# Technical Service Bulletin No. 27

**Reference no: C12**

## Affected models

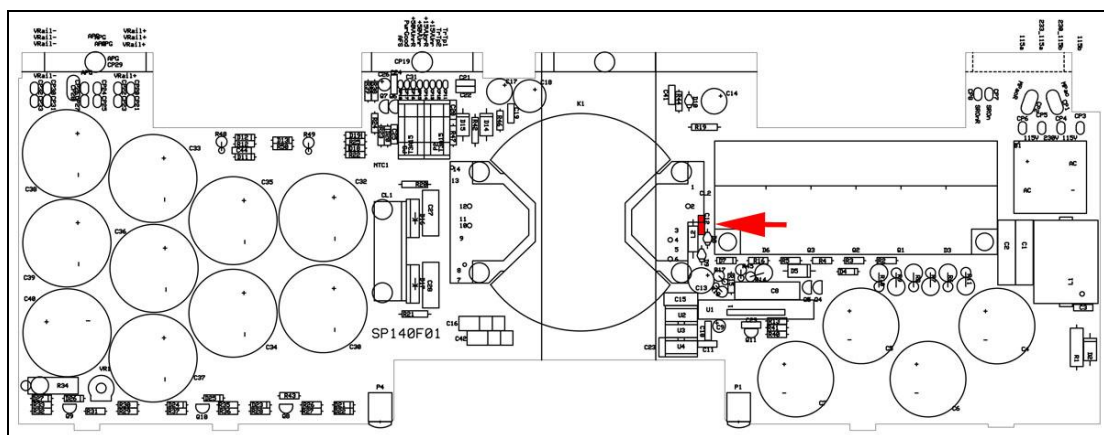
Screaming sound from power supply if amplifier powers up.

Amplifier does not power up.

Replace capacitor C12 with either of below listed components.

Lab Part No.	Description	Amount	Info	Pos
6n8250VMMK5	Wima: FKS2 6800PF 10% 400VDC	1		C12
6n8250VMMK5	Epcos: B32529-C3682-K289	1		C12
